**OUTLINE APPLICATION AT LAND OFF BASINGSTOKE ROAD, SPENCERS WOOD
(APPLICATION REFERENCE: 250517).**

Please accept this letter as a formal response to the consultee objection submitted by Fisher German dated 4th April 2025, in relation to the Exolum High-Pressure Oil Pipeline Apparatus, on behalf of Richborough ("the applicant"). We trust the following detail is sufficient to address their concerns.

Development Name;
Land at Spencers Wood, Wokingham
Title;
Gyo-Phys and Oil Pipeline Overlay
Date: 06/05/2025
Scale: 1:3000@A2
Drawing no: RE-SPWD-OPLO-SK01

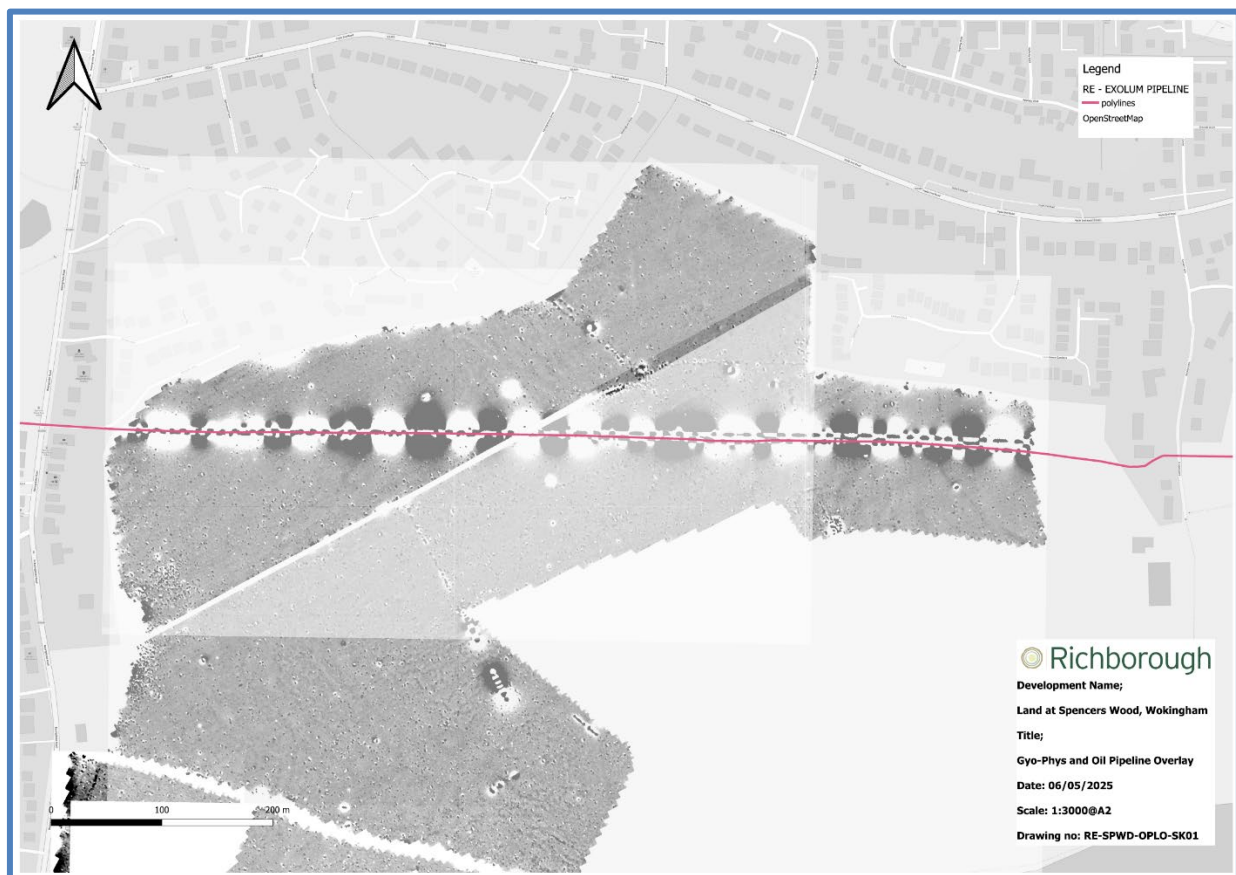
The following image (also found at Appendix 1) shows an overlay of the pipeline route from the asset records obtained from Exolum with geophysical survey work undertaken to support the Archaeological assessment work undertaken for the scheme. Note that there is a wider area of disturbance on the survey (which shows the extent of disturbed ground for the installation of the pipe) and a central more definitive area of disturbance which appears to pick up the pipeline itself.

The central area of ‘disturbance’ on the geophysical survey shows the general location of the pipeline and it can be seen that through the bulk of the proposed developed part of the application area the two datasets match well – indicating that the asset record plans are broadly

accurate in this locality. There is a slight potential divergence toward the eastern extent of the pipeline within the eastern parts of the site, but it is not significant and coincides with planned Public Open Space in that area of the site, as opposed to any built development (the proposed drainage basin has also been located outside of the indicative pipeline easement).
